Office Action Summary	Application No. 10/645,667	Applicant(s) KOB ET AL.	
	Examiner Vikansha S. Dwivedi	Art Unit 3746

DETAILED ACTION

Above Figure is Figure 3 of Mukaidani. The portion between A and B is a groove as disclosed in Claim 1.

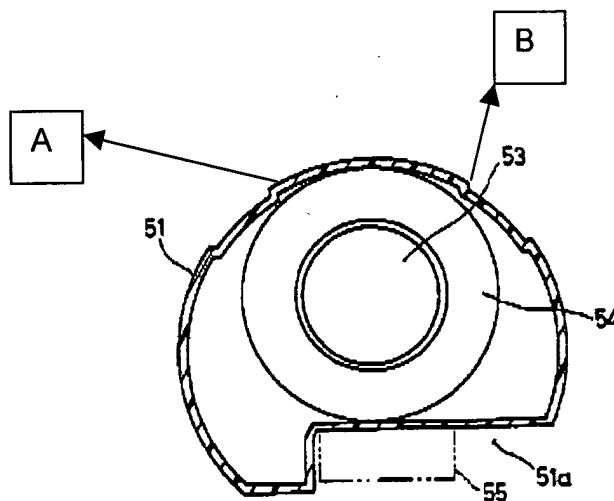
Mukaidani teaches a fuel tank (1, Figure 2 also described on Page 2) with a fuel pump (21, Figure 1). Mukaidani refers to his pump as "fuel pump" not "electrical fuel pump", though it is clear from the description and the Figure 2 which shows an electrical connector (14, Figure 2) that it is indeed an electrical fuel pump. It also discloses a connecting member as shown in figure 2 (42) and described on page 3, line 47 of the text, which Mukaidani refers to as connecting pipe.

Mukaidani sets forth a device as described above, which is substantially analogous to the claimed invention. The fuel supply device disclosed by Mukaidani differs from the claimed invention in that there is no explicit teaching of relative movement between the cover and the pump unit. Supporting portion lacks a through hole that penetrates through and receives the connecting member. Also, the supporting portion is not slidably engageable with the connecting member.
